UNITED STATES PATENT AND TRADEMARK OFFICE

APPLICATION NO.	FILING DATE	FIRST NAMED INVENTOR	ATTORNEY DOCKET NO.	CONFIRMATION NO.
10/627,893	07/25/2003	Eric C. Hannah	42P12034D2	3477

Office Action Summary

DETAILED ACTION

FIG. 5

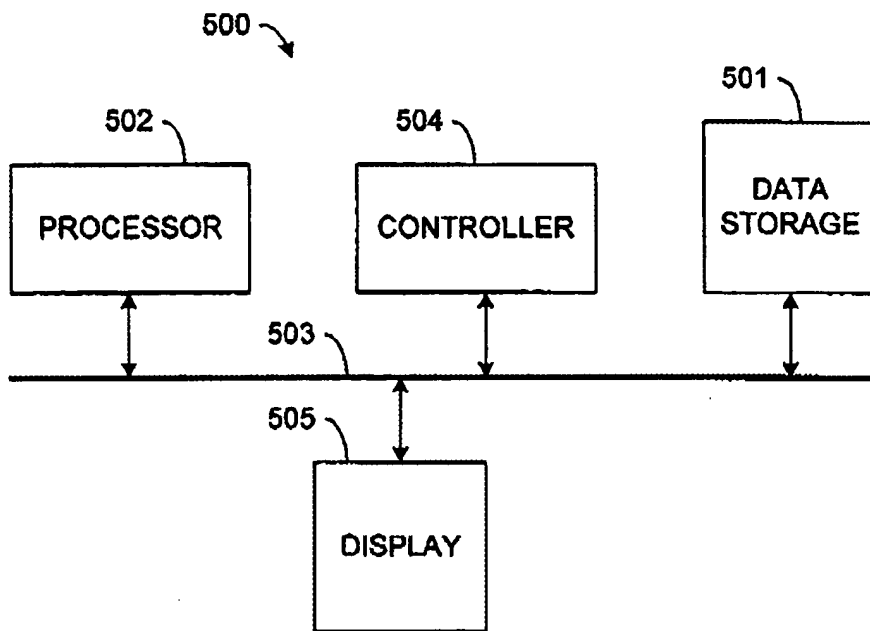
1. The drawings were received on 1/13/06. These drawings are acceptable.
2. The drawings are objected to under 37 CFR 1.83(a). The drawings must show every feature of the invention specified in the claims. Therefore, the feature as recited in claims 19-20 (Fig. 1 does not show any amplifier), 26 (Fig. 2 does not show any thin conductive interlayer to backwards bias P-N junction 211), 28 and 44 (Fig. 2 does not show any transparent layer) must be shown or the feature(s) canceled from the claim(s). No new matter should be entered.

Approved
TP
3/19/06
